S-GA.195

October 27, 1960.

MODIFICATION OF TYPE APPROVAL

CANADIAN METER COMPANY "A-225"
ALUMINUMCASE POSITIVE DISPLACEMENT GAS METER
AND OTHER SIMILAR TYPES

CANADIAN METER COMPANY "A-225" ALUMINUMCASE POSITIVE DISPLACEMENT GAS METER

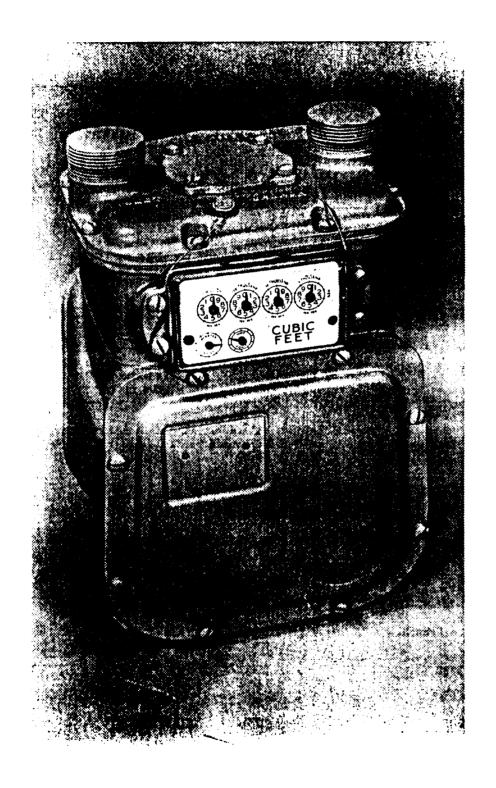
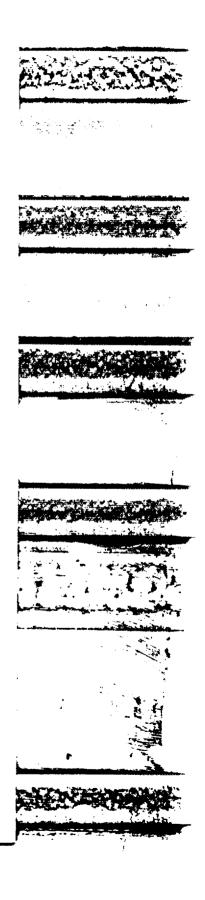
Modifications: The design of the top has been changed. The threaded handhole has been replaced by a handhole plate, held down by four filister head screws. The manner of sealing has been modified also. The sealing wire passes through two screws at the back, two screws on the front cover, one of the left-hand index box screws, one top flange screw and one handhole cover screw.
